Access Compliance Report

Public Rights-of-Way

Intersection ID: 27988	Main Street: JOHNSTON_RD	Cross Street: PROVIDENCE_RD_WEST	Location: NW
ADA ID: 97BB9F068DD1	Ramp Type: Perp	Initial Pass/Fail: Fail	Overall Compliance: No
Severity Score: 1.25			
Codes/Mitigation Info/Possible Solution		Field Measurements/Component Compliance

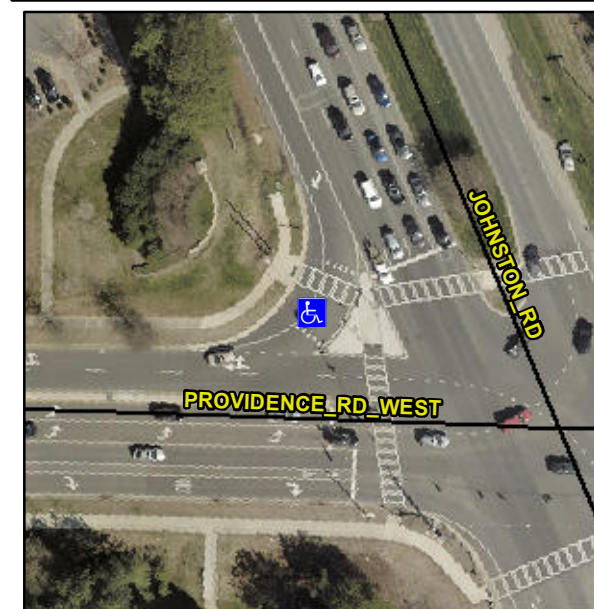
Not Found, R304.5.3

Compliance	Description	Data	Compliance	Description	Data
N/A	Ramp Length (in)	102.0	Yes	Ramp Slope (%)	6.7
Yes	Ramp Width (in)	48.0	No	Ramp XSlope (%)	2.2
N/A	Flare Type LT	N/A	N/A	Flare Type RT	N/A
N/A	Flare Slope LT (%)	N/A	N/A	Flare Slope RT (%)	N/A
N/A	Flare Traversable LT?	N/A	N/A	Flare Traversable RT?	N/A
N/A	Landing Length (in)	N/A	N/A	DWS Provided?	N/A
N/A	Landing Width (in)	N/A	N/A	DWS Contrast?	N/A
N/A	Landing Slope (%)	N/A	N/A	DWS Length (in)	N/A
N/A	Landing X Slope (%)	N/A	N/A	DWS Full Width?	N/A
N/A	Landing Curb? (Y/N)	N/A	N/A	DWS Offset (in)	N/A
N/A	Shared Landing?	N/A			
N/A	Gutter Ponding?	N/A	N/A	Gutter Slope (%)	N/A
N/A	Gutter Lip Ht (in)	N/A	N/A	Gutter X Slope (%)	N/A
N/A	Painted X Walk1?	Yes	N/A	Painted X Walk2?	N/A
	X Walk 1 Direction	To SE		X Walk 2 Direction	N/A
N/A	X Walk 1 Width (in)	127.0	N/A	X Walk 2 Width (in)	N/A
	X Walk 1 Slope (%)	0.9		X Walk 2 Slope (%)	N/A
	X Walk 1 X Slope (%)	1.3		X Walk 2 X Slope (%)	N/A

Remove & Replace Entire Ramp.
